"10/5": The Residents' Solution

A common sense solution for safe and
convenient parking in West Harrow Village

Presented by the West Harrow Residents' Group

18 March 2011

Schedule "B" The 5/5 Option

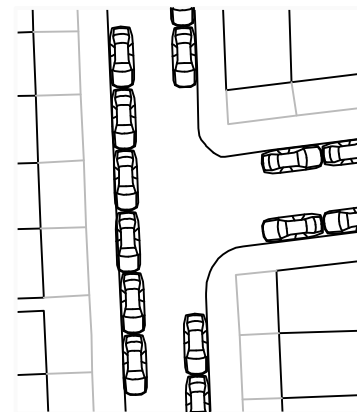
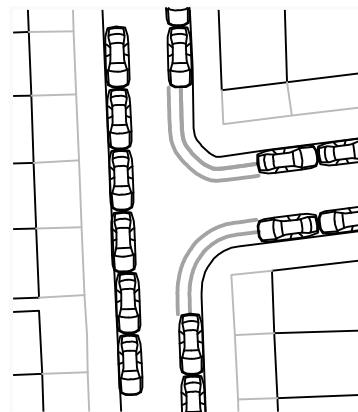
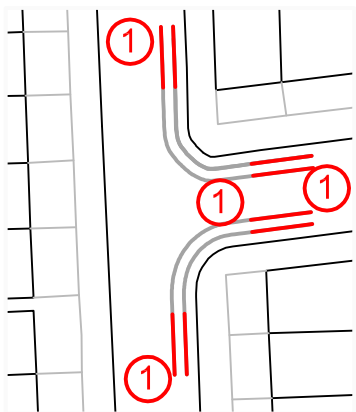
Please refer to Schedule "B" which demonstrates parking at a crossroad when the DYLS extend five metres. If the area is subject to maximum cars parked it is anticipated that large vehicles may experience:

- 6) On the rare occasion of an emergency, The "5/5" Solution would enable fire engines to negotiate junctions in the Village with ease.
- 7) If The "5/5" Solution is adopted it is estimated that at least 110 car parking spaces will be retrieved for residents who live in the Middle Section of the Village.

Car parks recovered:
IN CPZ: ~24
OUT CPZ: ~86
TOTAL: ~110

Schedule "C" The 10/5 Option

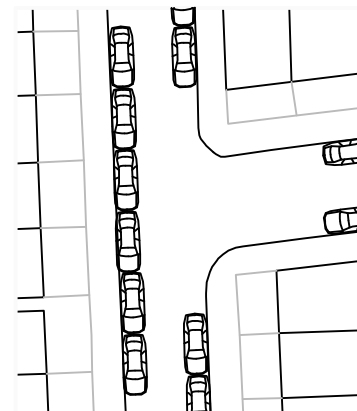
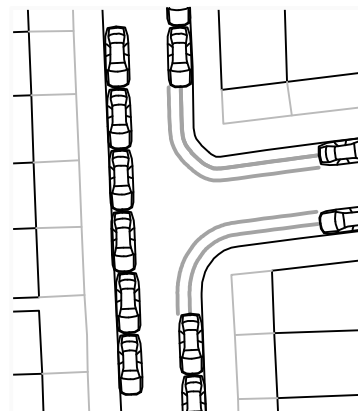
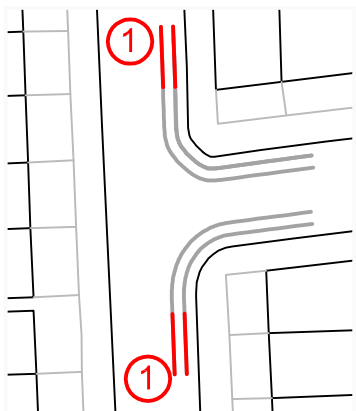
Please refer to Schedule "C" which demonstrates parking at a crossroad where the DYLS extend one side for five metres and the corresponding side for 10 metres. If the area is subject to maximum cars parked it is anticipated that larger vehicles may experience:

- 8) If The "10/5" Solution is adopted it is estimated that at least 70 car parking spaces will be retrieved for the residents who live in the Middle Section of the Village.

The Council designed the DYLS solely with the aid of a computer software package and ignored all other considerations. WHRG has consulted widely and now proposes The "10/5" Solution - a common sense solution for safe and convenient parking the the Village

- 1) The "10/5" Solution which allows large emergency vehicles such as fire engines to negotiate junctions in the Village with ease.
- 2) The "10/5" Solution which allows adequate visibility for pedestrians and car users but will not give too much visibility which encourages drivers to use excessive speed in the Village.

- 3) The "10/5" Solution which will provide an extra 70 car parking spaces in the Middle Section of the Village and will provide much more additional parking when The 10/5 Solution is applied to the whole of West Harrow Harrow Village, so improving the standard of living of those residents who have a car and need a space to park their car.

Car parks recovered:
IN CPZ: 11
OUT CPZ: 59
TOTAL: 70

Schedule "D" The 10/10 Option

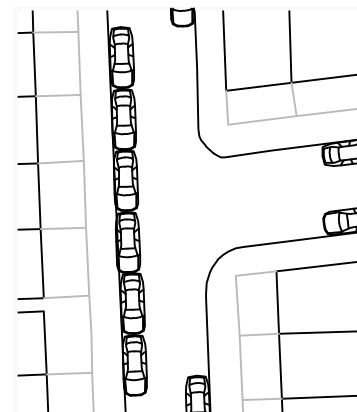
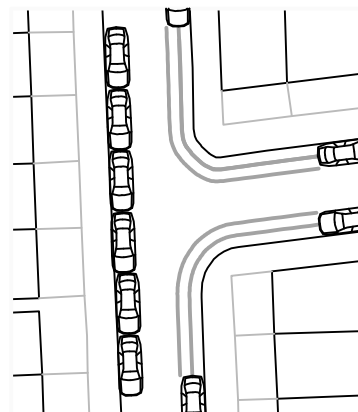
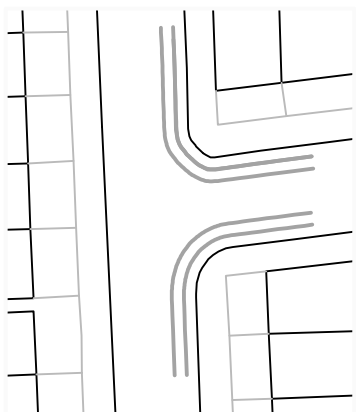
Please refer to Schedule "D" which demonstrates parking at crossroads where the DYLS extend to 10 metres on every corner. This option is currently adopted by the Council in the Village. If the area is subject to maximum cars parked it is anticipated a large vehicle may experience:

- 1) The Council, by introducing DYLS at the maximum length of 10 metres, failed to consider the increased speed of vehicles due to the greater visibility afforded by the DYLS.

- 2) The Council, by introducing DYLS at the maximum length of 10 metres, simply took too many car parking spaces from the Village. In the evenings and at night, when only residents park, there are just not enough car parking spaces.

- 3) The Council, by introducing DYLS at the maximum length of 10 metres, has caused heated arguments between neighbours when parking and, according to Police statistics, an increase of 350% in reported car crime in the four months following the installation of the CPZ.
